ADDENDUM TO REQUEST FOR PROPOSAL DOCUMENT
FOR
Moosomin Dam
Service Contract No. 5
Dam Safety Review
REQUEST FOR PROPOSAL # 4547:928-7P11-0-S1-5

Addendum No. 3

Q&A:

AS CONSTRUCTED	SUBMITTED BY: <i>[Signature]</i>	DATE: <i>January 7/93</i>
PIPESTONE CREEK (MOOSOMIN DAM) PROJECT		
CONTRACT 4 - DAM AND SPILLWAY REHABILITATION		
SPILLWAY DRAINAGE SYSTEM		
MANHOLE DETAILS		
Scale AS SHOWN	Date JUNE /90	Sheet 5 of 8
C116090

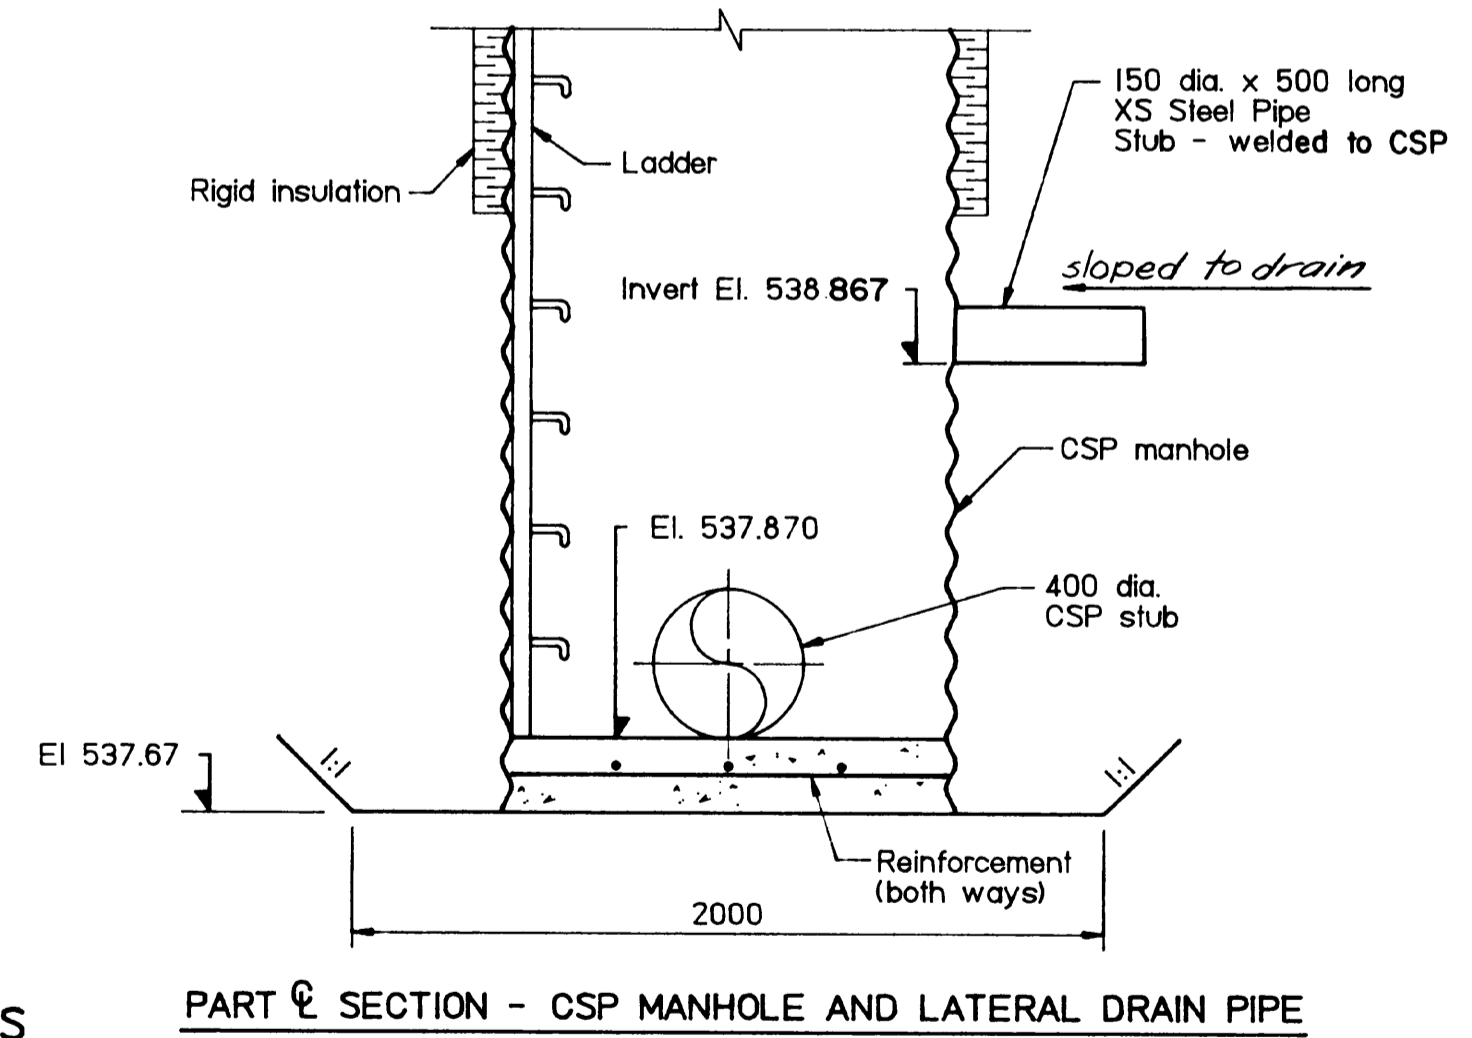
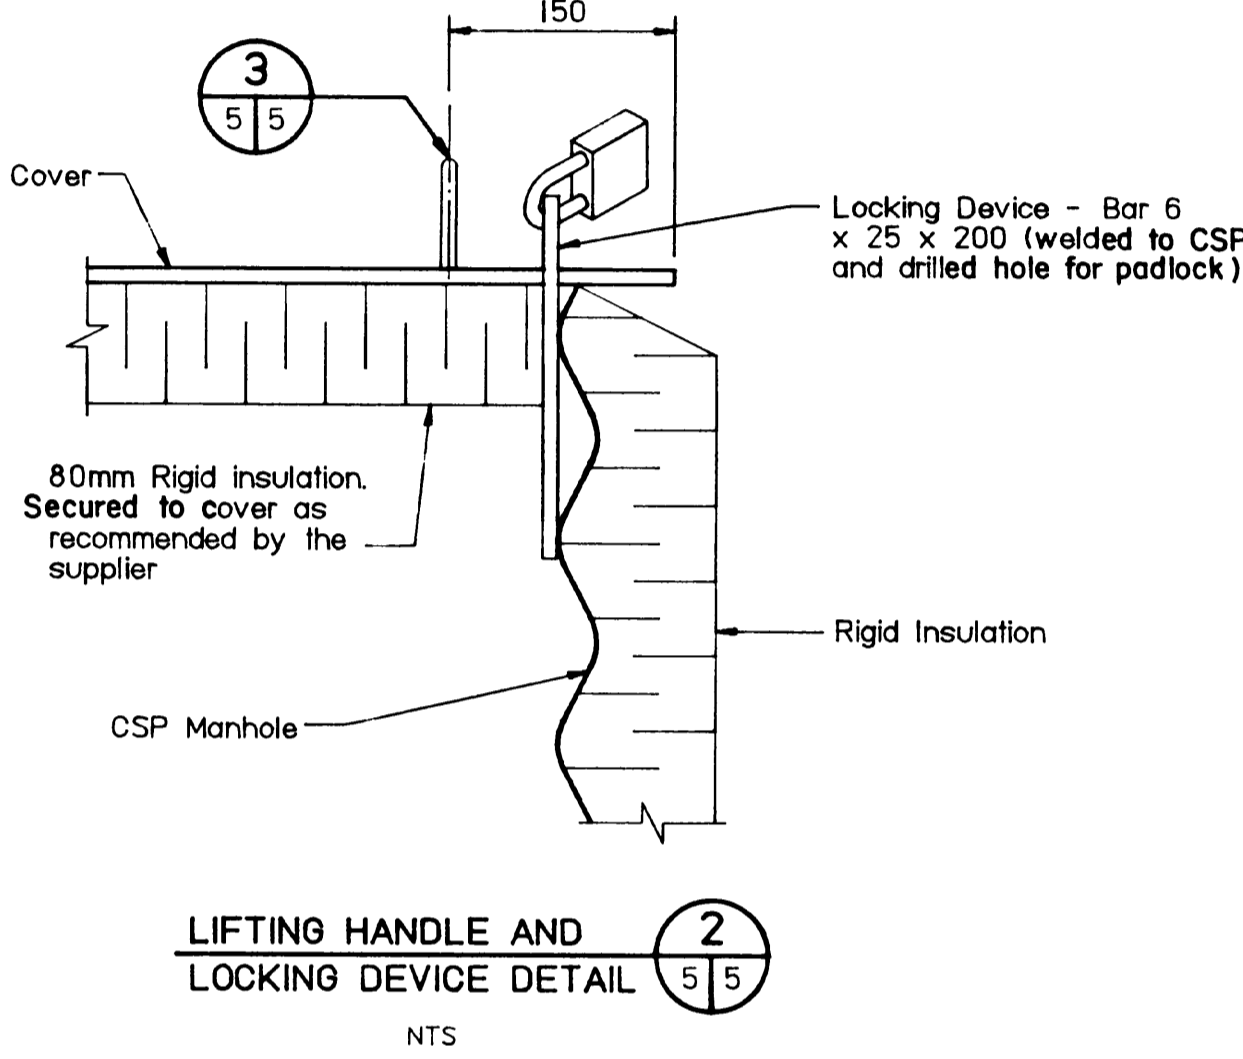
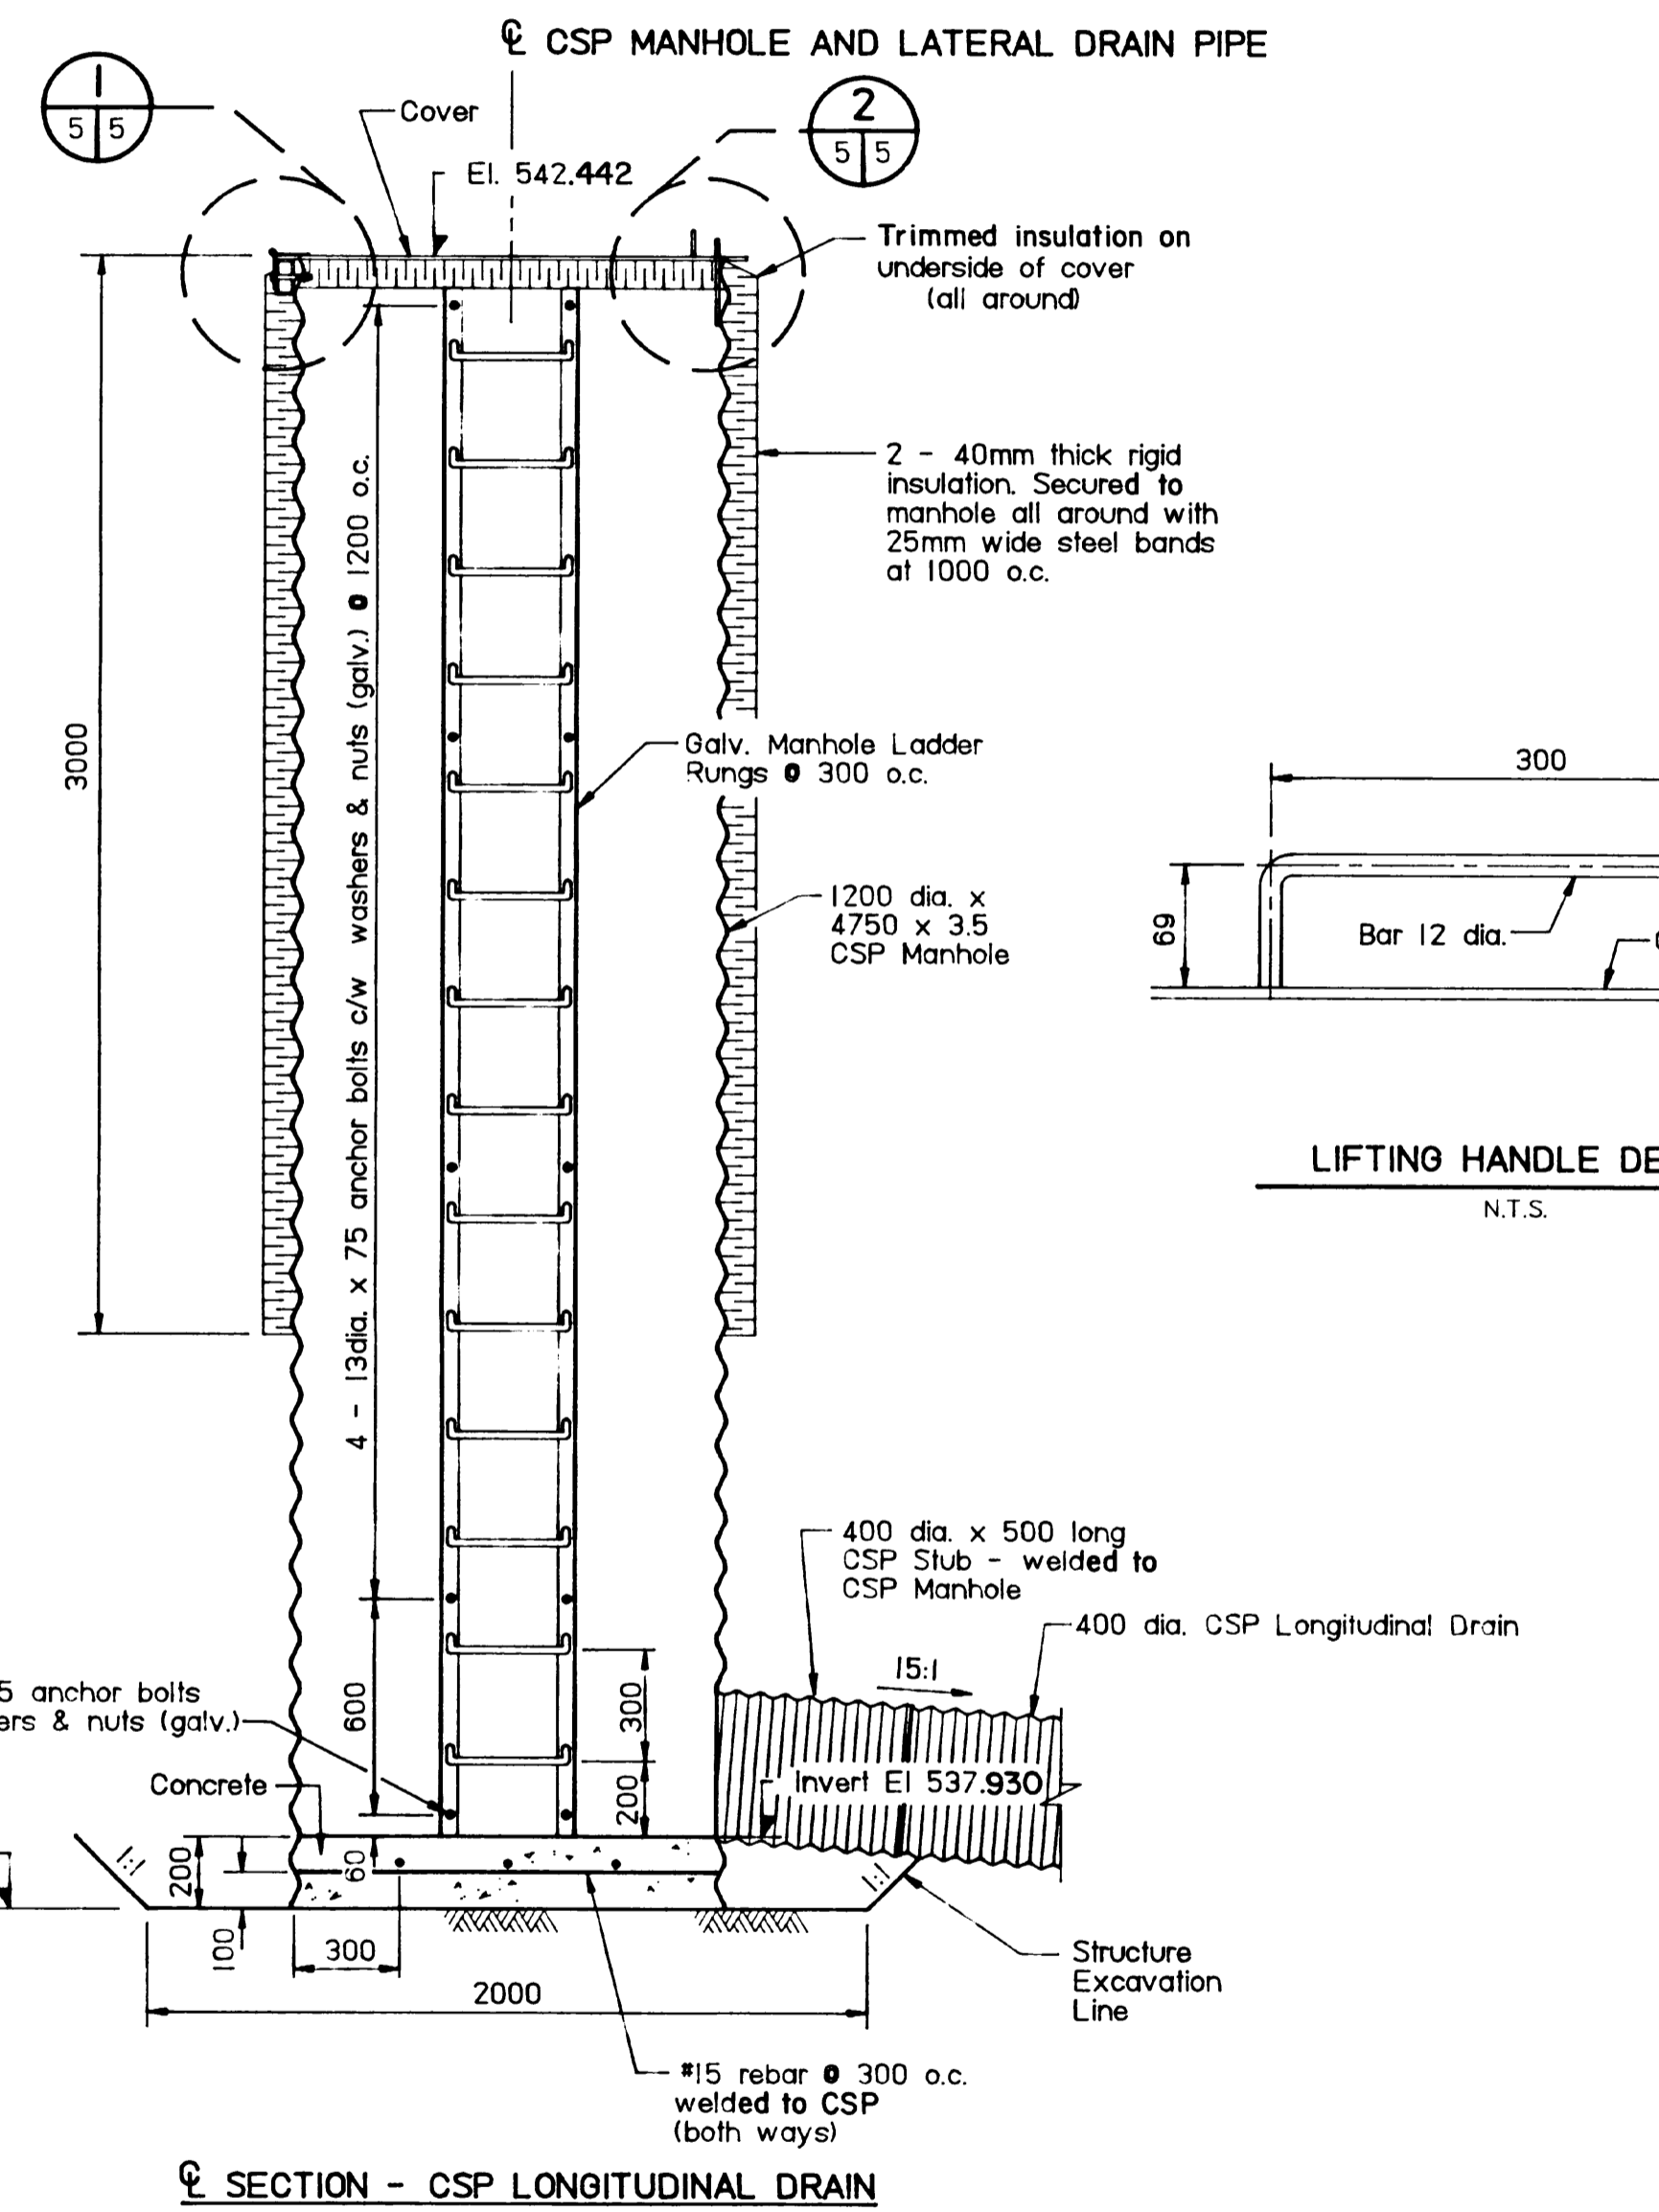
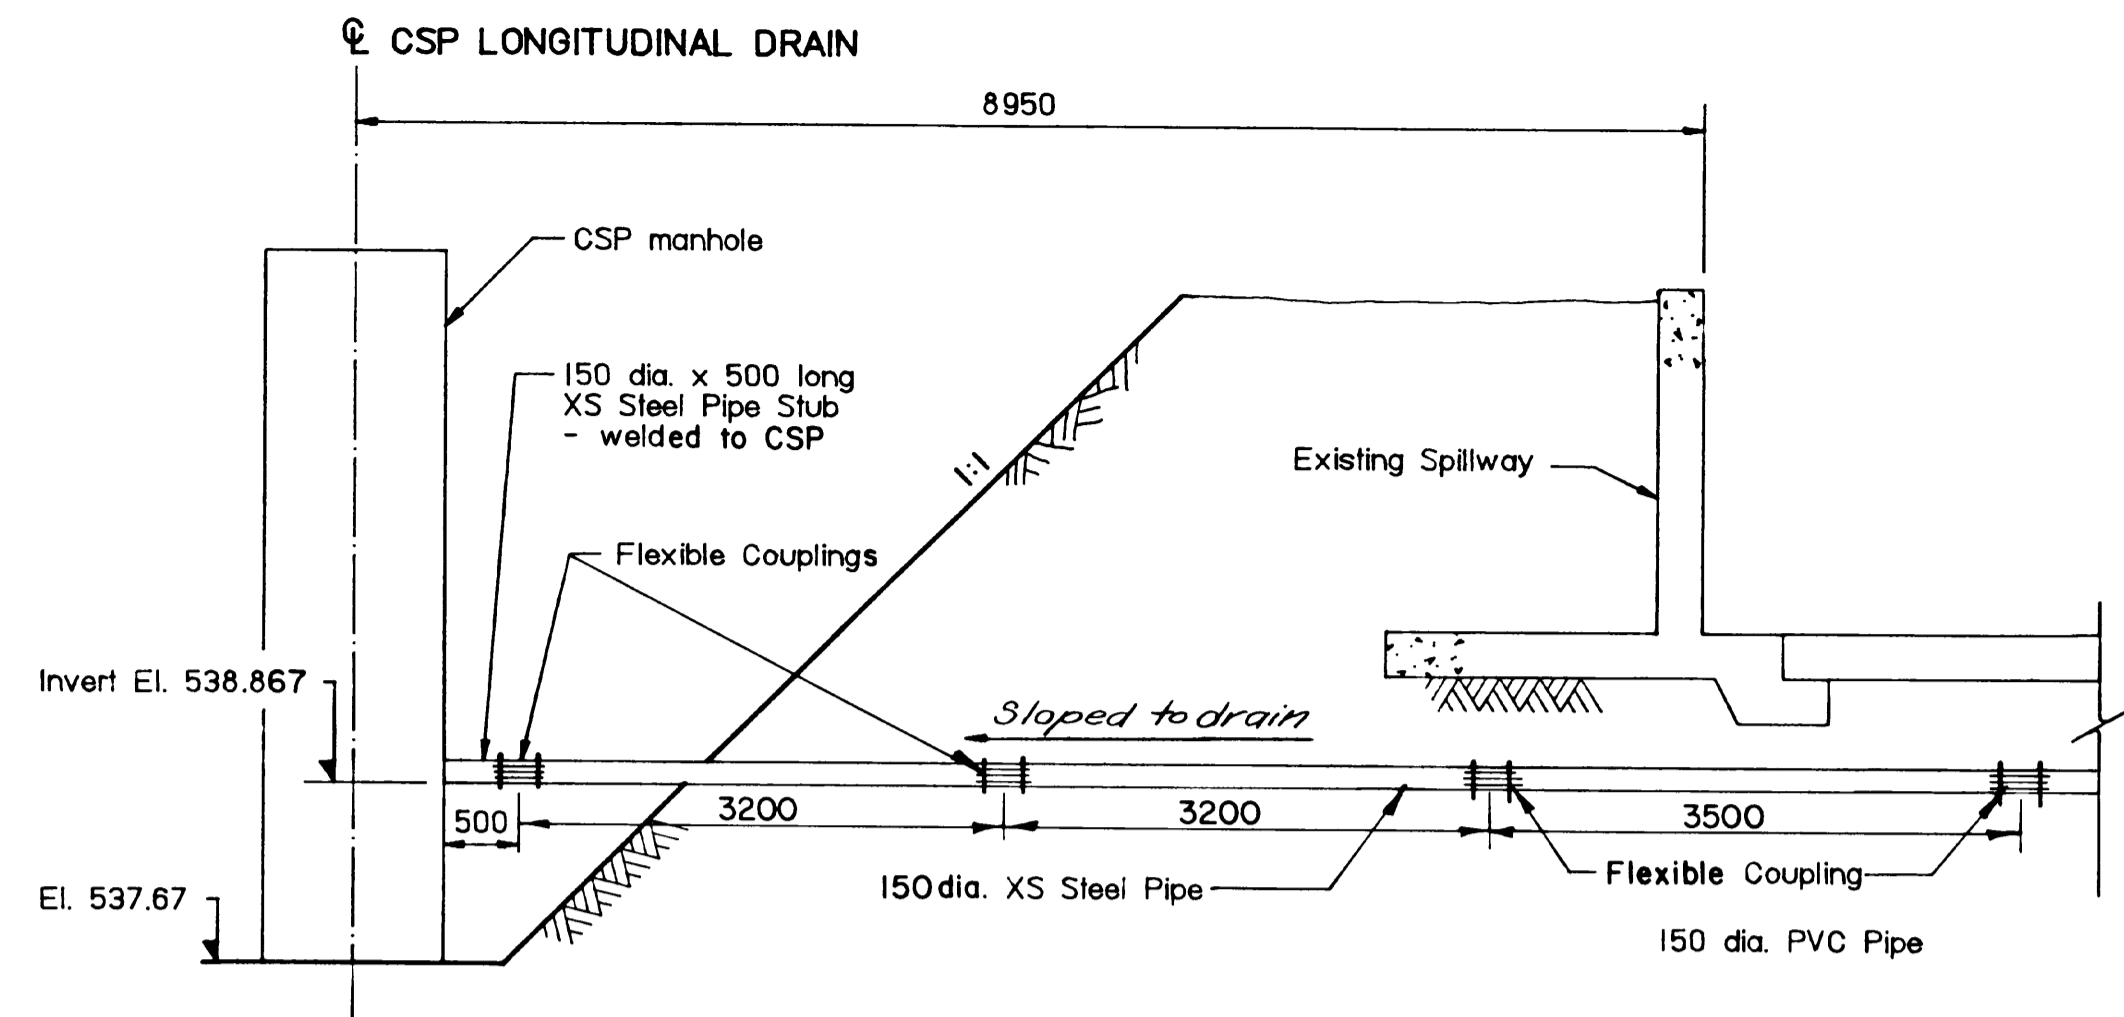
Q8 - Can AAFC provide additional details on the CURRENT layout of the underslab drainage system including the diameter of the drain pipes. The drawing provided (C208544) only displays two transverse drains that have been removed. We are interested in the pipe diameter and length of transverse drains.

A8 - The drawing provided with the configuration of the spillway did not include all the details of the drainage system. In 1990 and in 2001, the drainage system was repaired and the original transverse drain pipes were replaced with 150mm dia PVC pipes. The attached drawings show the relevant drainage system details.
